Access Audit Site Report

Prepared By
WT Group

Martin Dies Jr. State Park
634 Park Road 48 South
Jasper, TX 75951
Accessibility Evaluation
Inspection Date: 11/10/2021
Inspectors: Tanya Scheibe

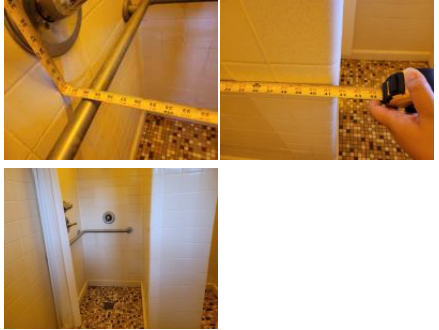
352	Walnut Ridge Unit (Sites 500-548): Walnut Ridge Unit (Sites 500-548) Men's Shower Bldg 5A	[30.8587284, -94.179279]	The space between the wall and the grab bar shall be 1½ inches (38 mm). The space between the grab bar and projecting objects below and at the ends shall be 1½ inches (38 mm) minimum. The space between the grab bar and projecting objects above shall be 12 inches (305 mm) minimum. EXCEPTION: The space between the grab bars and shower controls, shower fittings, and other grab bars above shall be permitted to be 1½ inches (38 mm) minimum.	Grab bars exceed 1.5" between bars and walls	Replace grab bar with one providing 1.5" gap between bar and wall and mount so no objects interfere within 1.5" below and 12" above bar.	2010 ADAS Section: 609.3, 609.3 Exception		 <p>(a) projecting objects (b) recessed objects 1 1/2" min.</p>

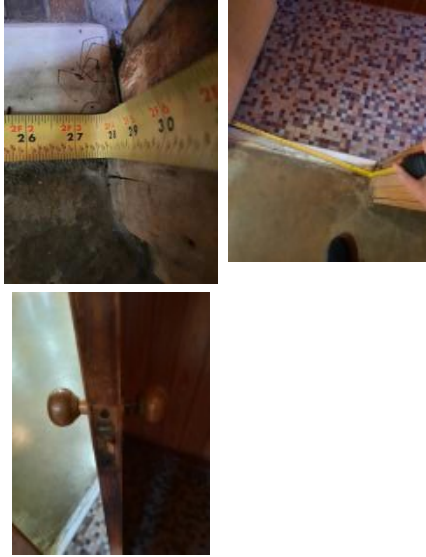
376	Walnut Ridge Unit : Walnut Ridge Unit Group Hall With Kitchen	[30.8623801 , -94.181931 7]	The fire extinguisher projects more than 4 inches into the circulation path. Wall-mounted objects that have leading edges between 27 inches and 80 inches from the floor must not project more than 4 inches into the circulation path. Protruding objects that extend to the floor or within 27 inches of the floor are cane detectable and are therefore not hazardous. Where it is necessary or desirable to have objects protrude from the wall, a manner of cane detection must be provided.	Dining Hall - Fire extinguisher protrudes 5"	Relocate protruding objects or place cane detectable warning or bollard at foot of item.	2015 ABAAS Section: 307.2 2012 TAS Section: 307.2 2010 ADAS Section: 307.2

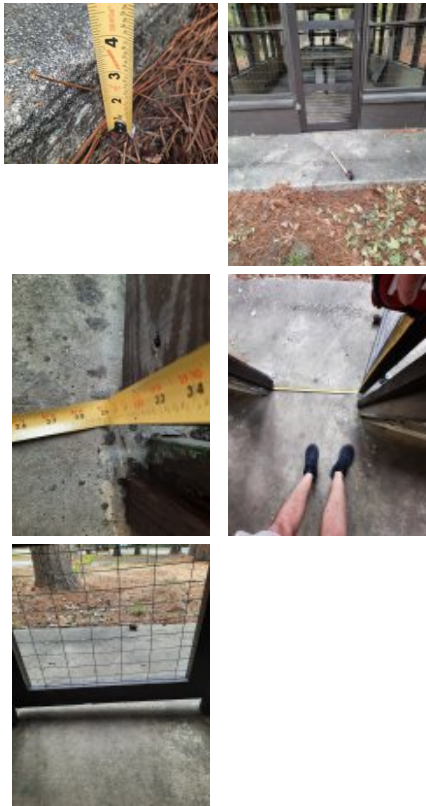
391	Walnut Ridge Unit : Walnut Ridge Unit Group Hall With Kitchen Women's Restroom	[30.8623663 , -94.181971 9]	The restroom is not compliant. The restroom does not have the required minimum clear floor space or maneuvering clearances for the toilet. The restroom does not have the required minimum clear floor space or maneuvering clearances for the lavatory. The entry door does not contain the required minimum maneuvering spaces on the pull/push sides. The entry door encroach into the required clear floor space for fixtures. Grab bars are missing and/or incorrectly installed. Accessories, such as toilet seat covers, paper towel holders, garbage cans, hand dryers, and mirrors are either too high or without clear floor space or both.	Restroom is not accessible and lacks signage directing patrons to an accessible restroom	Create a compliant wheelchair accessible restroom and correct all features to be accessible if feasible.	2015 ABAAS Section: 603.1 2012 TAS Section: 603.1 2010 ADAS Section: 603.1

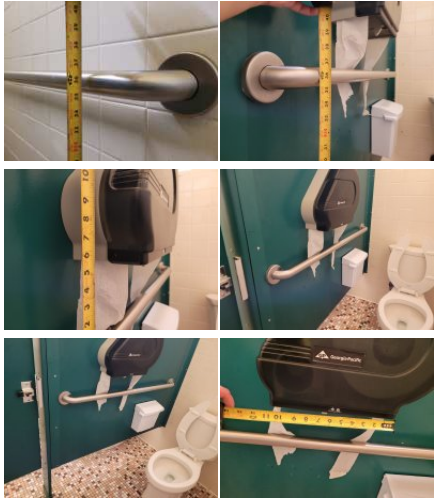
415	Walnut Ridge Unit (Shelter Sites 600-625): Walnut Ridge Unit (Shelter Sites 600-625) Men's Restroom Bldg 6	[30.8652397 , -94.181019 7]	The stall door fails to comply with all of the door requirements. The stall door must be a minimum of 32" wide and have compliant hardware on both sides. The stall door must be self-closing. Minimum maneuvering clearances at doors and gates shall comply with 404.2.4. Maneuvering clearances shall extend the full width of the doorway and the required latch side or hinge side clearance.	Lacks maneuvering clearance on pull side and lacks self-closing door	Reverse door to swing inward for door maneuvering clearance. Adjust stall door to be self-closing.	2015 ABAAS Section: 404.2.3, 404.2.7, 604.8.2.2 2012 TAS Section: 404.2.3, 404.2.7, 604.8.2.2 2010 ADAS Section: 404.2.3, 404.2.7, 604.8.2.2

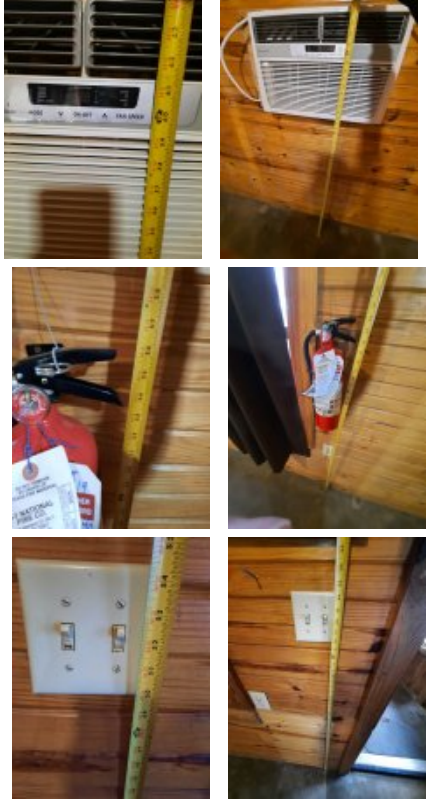
433	Walnut Ridge Unit (Shelter Sites 600-625): Walnut Ridge Unit (Shelter Sites 600-625) Women's Shower Bldg 6	[30.8652351 , -94.181019 7]	The bench is not deep enough or long enough or is missing. Benches shall be provided having seats that are 42 inches long minimum and 20 inches deep minimum and 24 inches deep maximum. The bench shall provide for back support or shall be affixed to a wall. Back support shall be 42 inches (1065 mm) long minimum and shall extend from a point 2 inches (51 mm) maximum above the seat surface to a point 18 inches (455 mm) minimum above the seat surface. Back support shall be 2½ inches (64 mm) maximum from the rear edge of the seat measured horizontally. The top of the bench seat surface shall be 17 inches (430 mm) minimum and 19 inches (485 mm) maximum above the finish floor or ground. Clear floor or ground space complying with 305 shall be provided and shall be positioned at the end of the bench seat and parallel to the short axis of the bench	Bench lacks required dimensions - 12.5" deep and lacks clear floor space	Replace bench in dressing area with one having a seat depth of 20" to 24" deep, 42" long, affixed to the wall or having a back and mounted 17" to 19" AFF and provide required clear floor space on the short axis of the bench.	2012 TAS Section: 903.4, 903.2, 903.3, 903.5 2010 ADAS Section: 903.4, 903.2, 903.3, 903.5

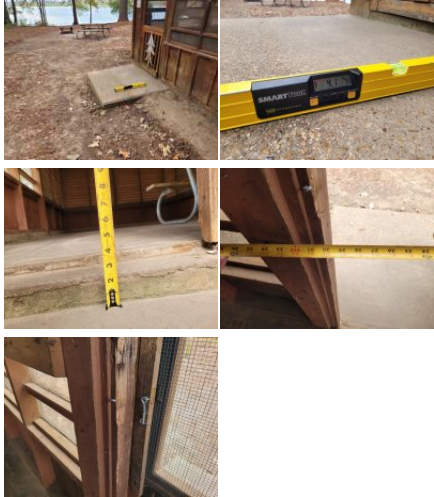
451	Walnut Ridge Unit (Shelter Sites 600-625): Walnut Ridge Unit (Shelter Sites 600-625) Shelters with Amenities	[30.8641691, -94.182114]	The surface of parking spaces and pull-up spaces shall be firm and stable. The slope of the surface of parking spaces and pull-up spaces shall not be steeper than 1:48 in any direction. EXCEPTION: Where the surface is other than asphalt, concrete, or boards, slopes not steeper than 1:20 shall be permitted when necessary for drainage.	Shelter 619 - Slope of 6.2% in "parking space"	Correct surface of parking spaces to be firm and stable with slopes max of 5% for surfaces other than concrete, asphalt or boards as a smart practice.	2015 ABAAS Section: 1012.4, 1012.5, 1012.5 EXCEPTION

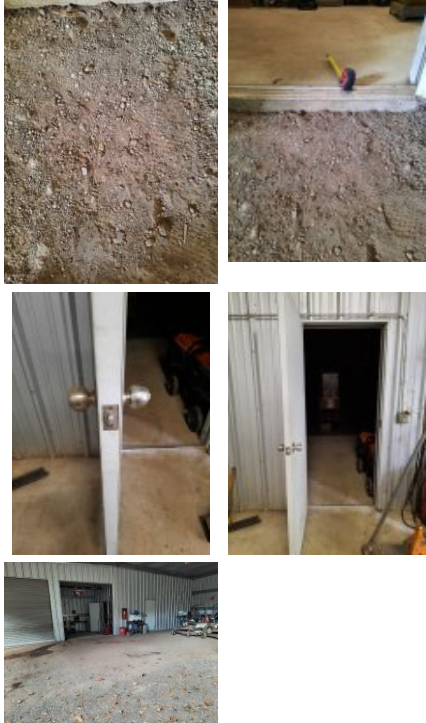
463	Walnut Ridge Unit (Shelter Sites 600-625): Walnut Ridge Unit (Shelter Sites 600-625) Shelters with Amenities	[30.8641668 , -94.181813 6]	Fire building surfaces shall be 9 inches (230 mm) minimum above the ground.	Fire building surface is at the same grade as surrounding ground level	Correct fire building surface to be 9" min above the ground as a smart practice. In the alternative, replace fire ring with a compliant accessible fire ring.	2015 ABAAS Section: 1011.5.1		
464	Walnut Ridge Unit (Shelter Sites 600-625): Walnut Ridge Unit (Shelter Sites 600-625) Shelters with Amenities	[30.8641829 , -94.181819]	30 inches (760 mm) by 60 inches (1525 mm) with the long side of the space adjoining or overlapping an accessible parking space or pull-up space for recreational vehicles Locate the space so that the hook-ups are at the rear center of the space. Bollards or other barriers shall not obstruct the clear ground space in front of the hook-ups	Shelter 618 - Lacks accessible route to and clear ground space at water spout	Provide required 30" by 60" clear ground space with hook ups at the rear of the space as a smart practice	2015 ABAAS Section: 1011.2
